ADDENDUM NO. 3

November 5, 2021

CROWN POINT HIGH SCHOOL ADDITIONS AND RENOVATIONS
Crown Point, IN 46307

This Addendum consists of Pages ADD 3-1 through ADD 3-2 and attached Addendum No. 3 from Gibraltar Design dated November 4, 2021 and consisting of 19 pages, Specification Section 08 34 73 - Sound Control Door Assemblies, Specification Section 11 66 43 - Scoreboards, and 107 drawings.

1 A-119 UNIT "B" SECOND FLOOR PLAN

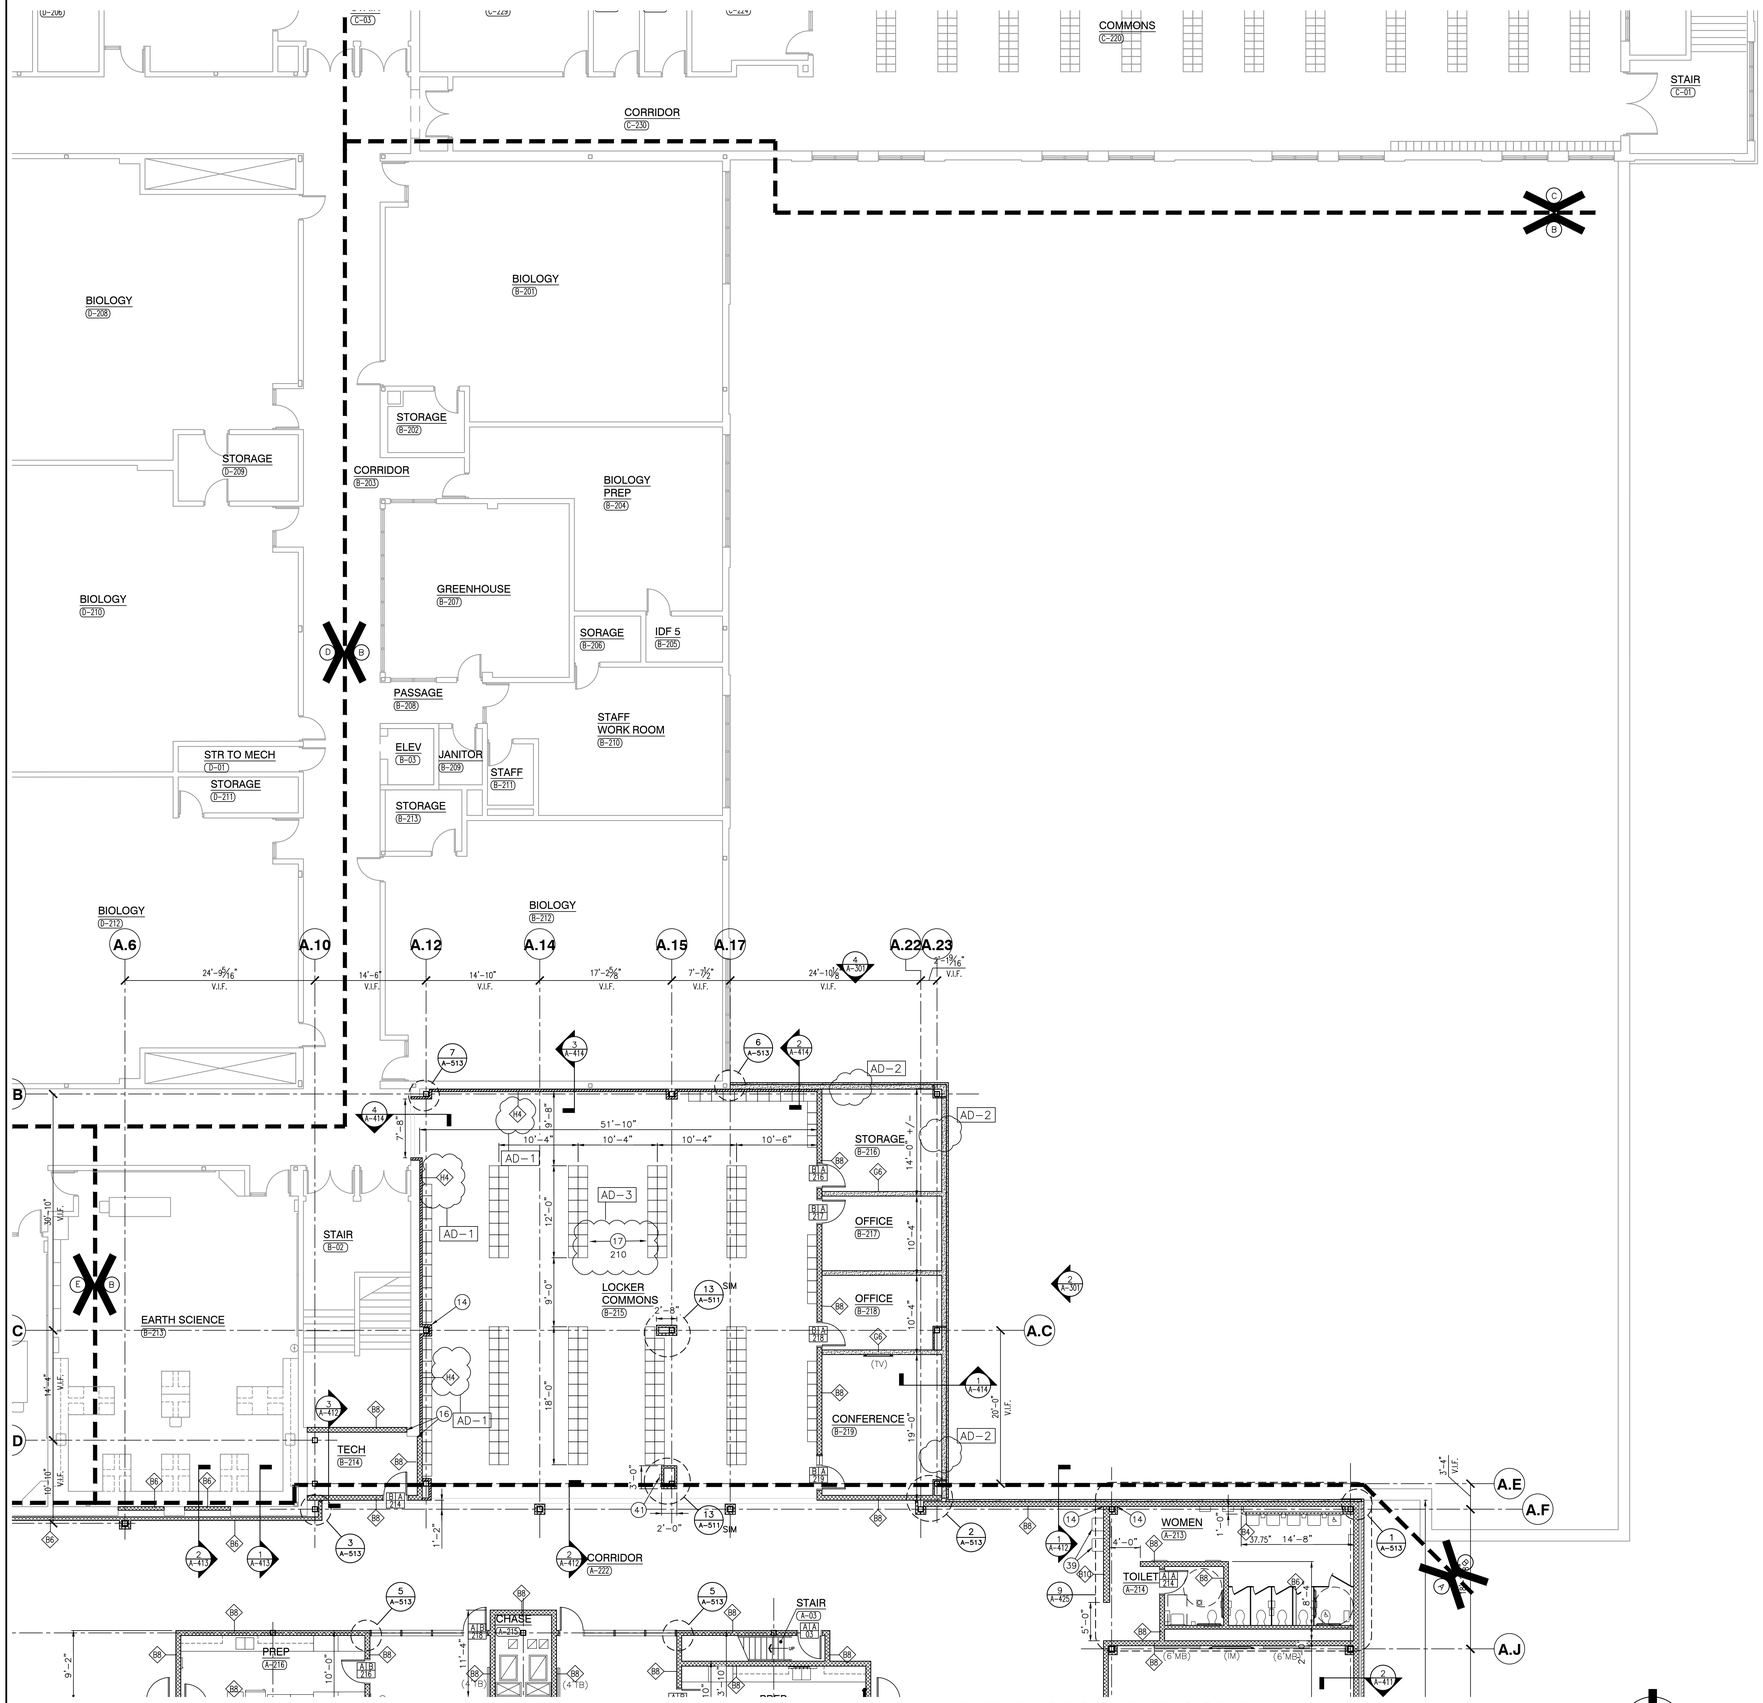
19. Sheet A-119

1 A-134

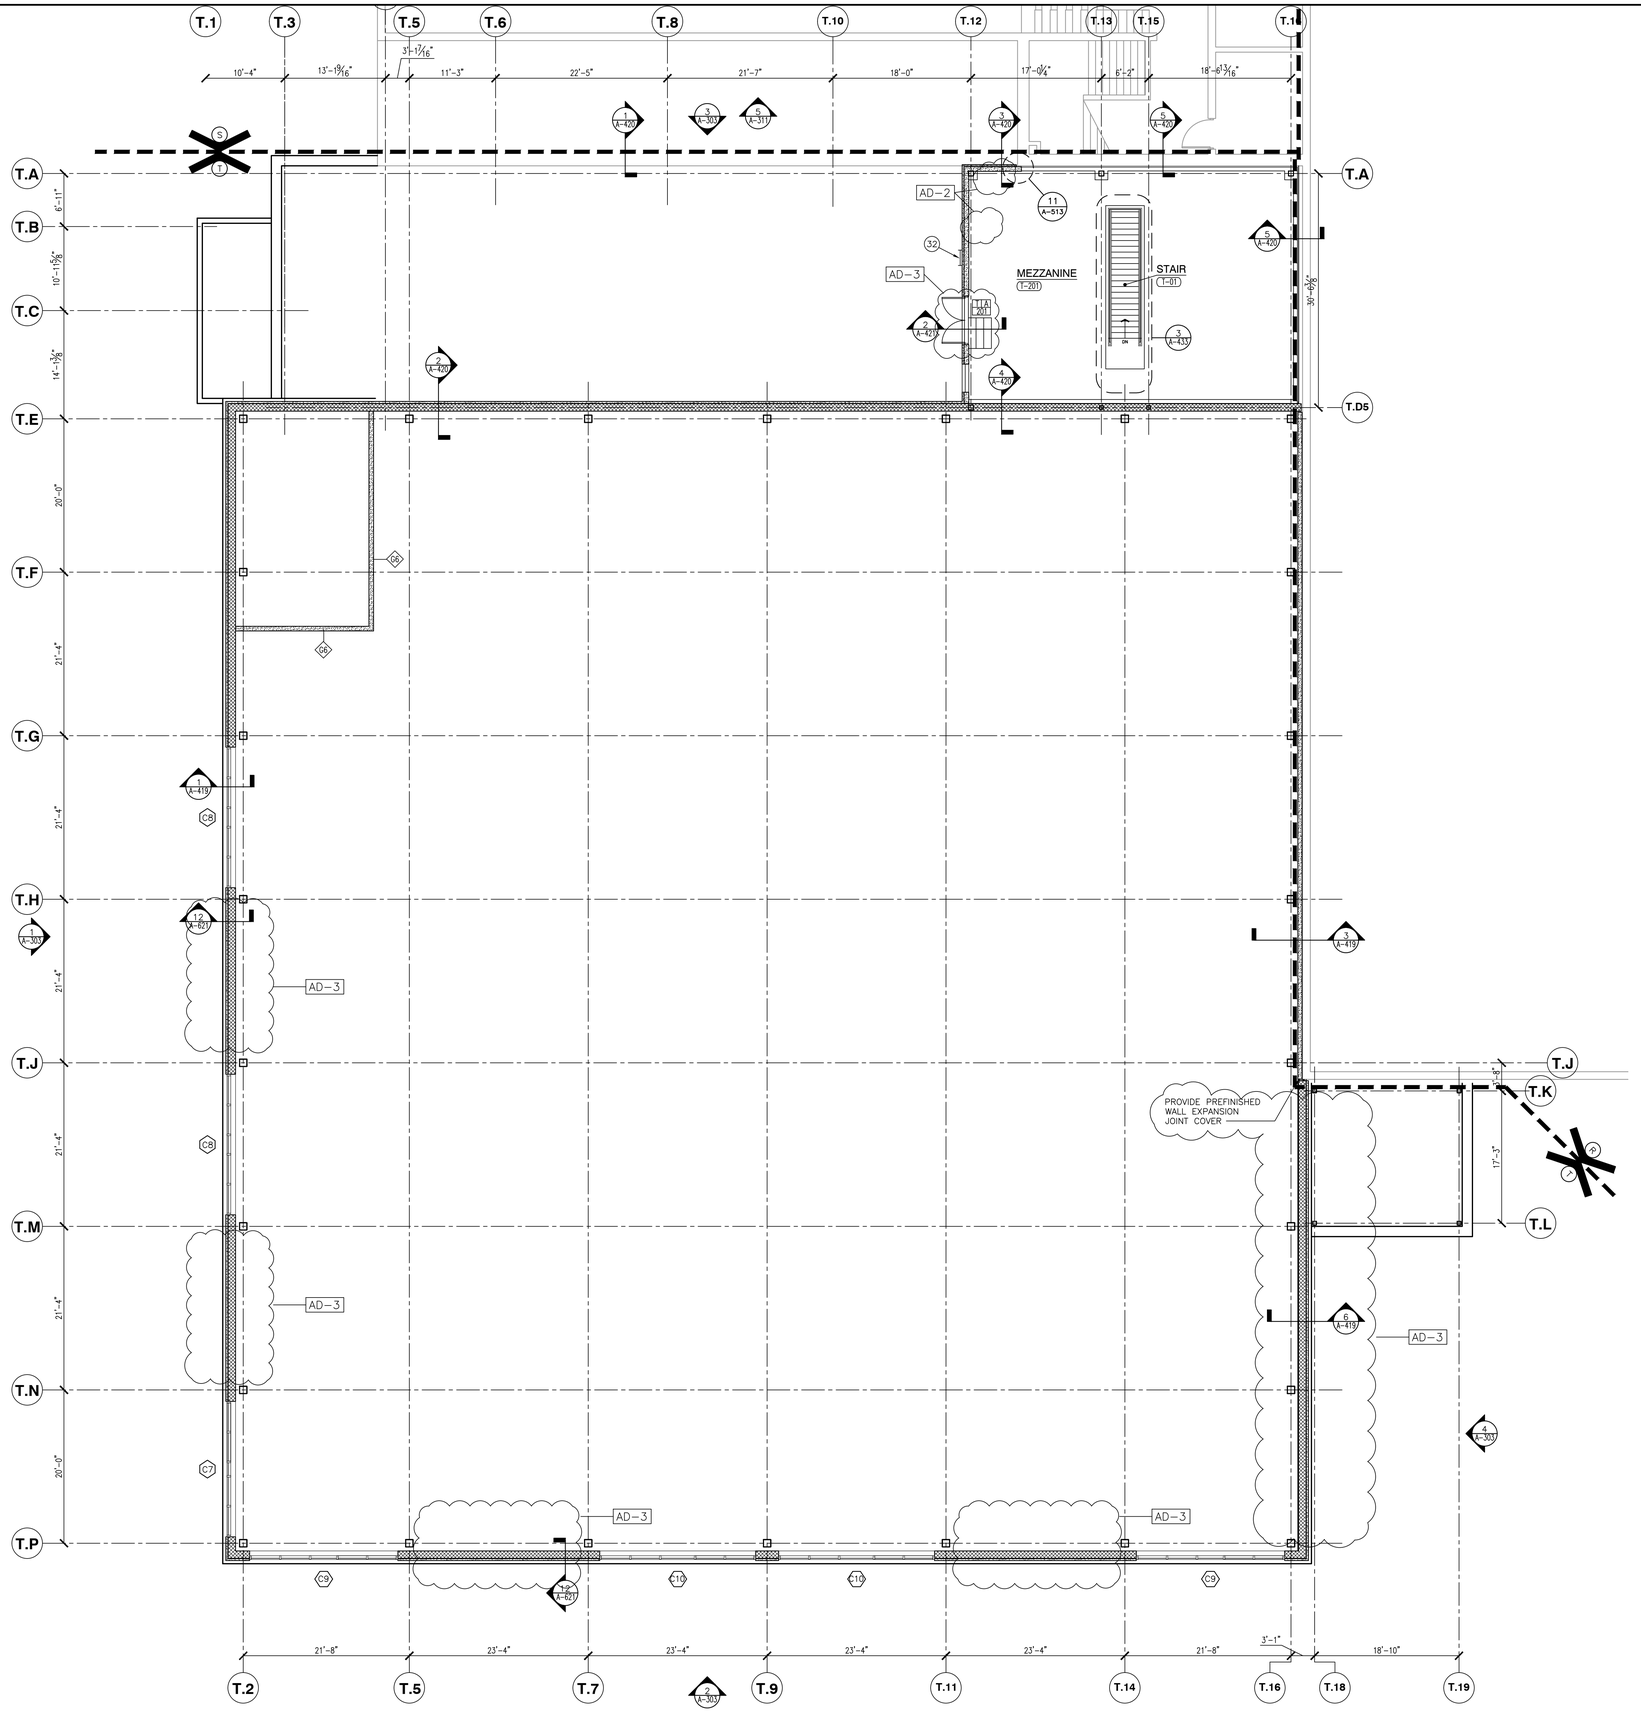
20. Sheet A-134

SHEET
D
EL104

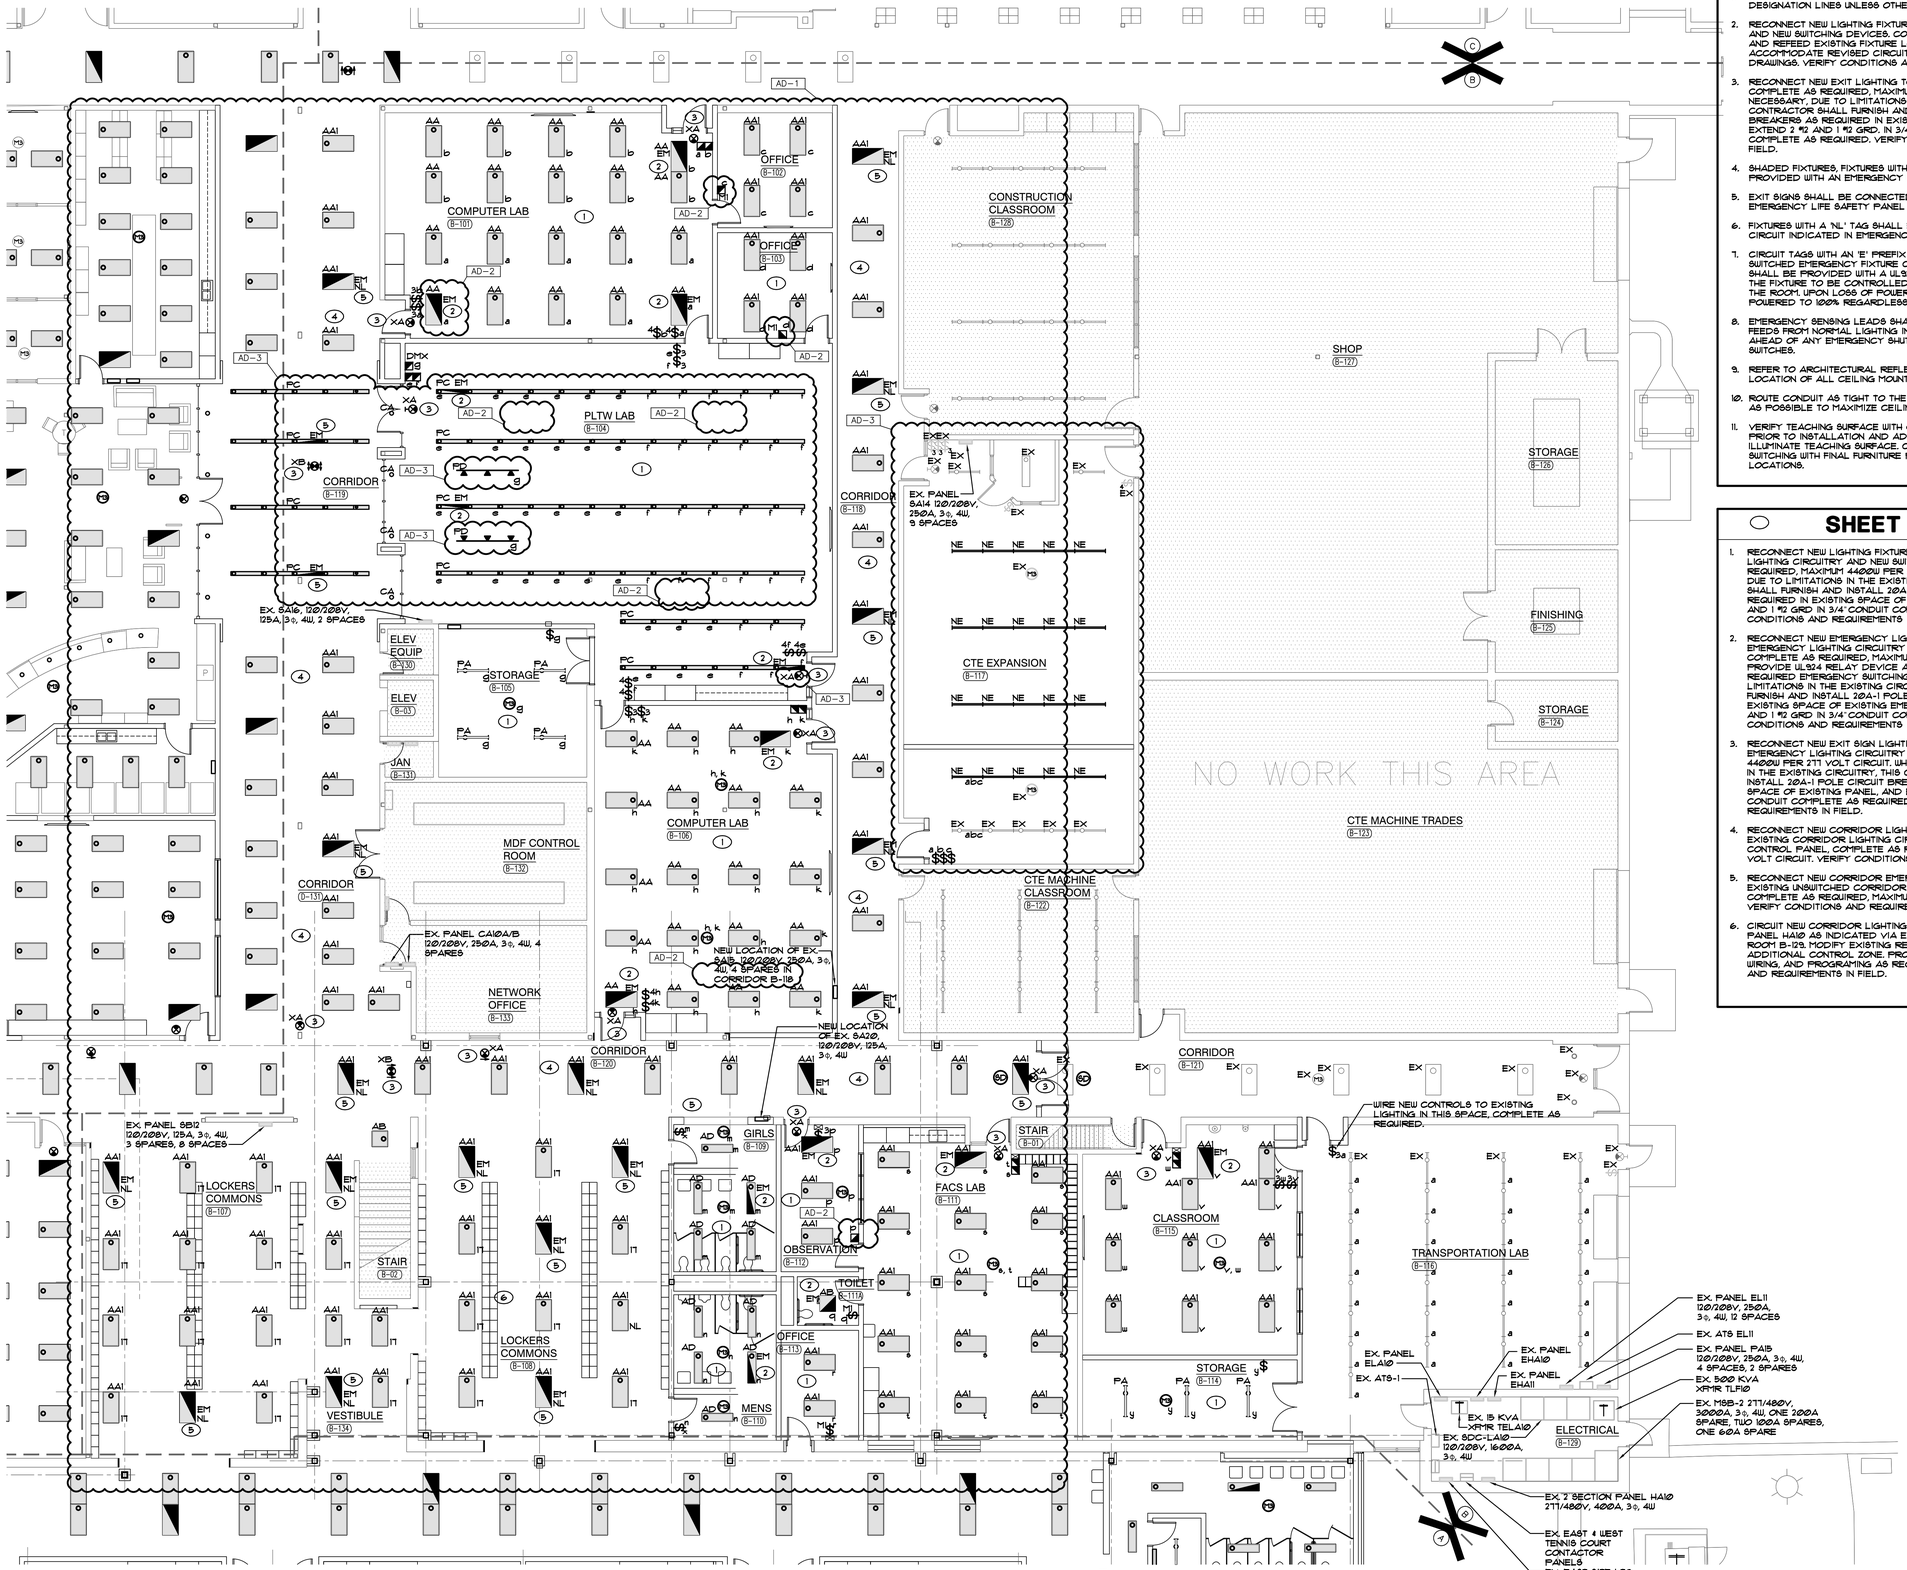
72. Sheet EL104

1. Refer to the attached sheet EL104 for the following revisions:
2. Added sheet notes.
3. Added pipe batten grid.
4. Added plug-in busway.
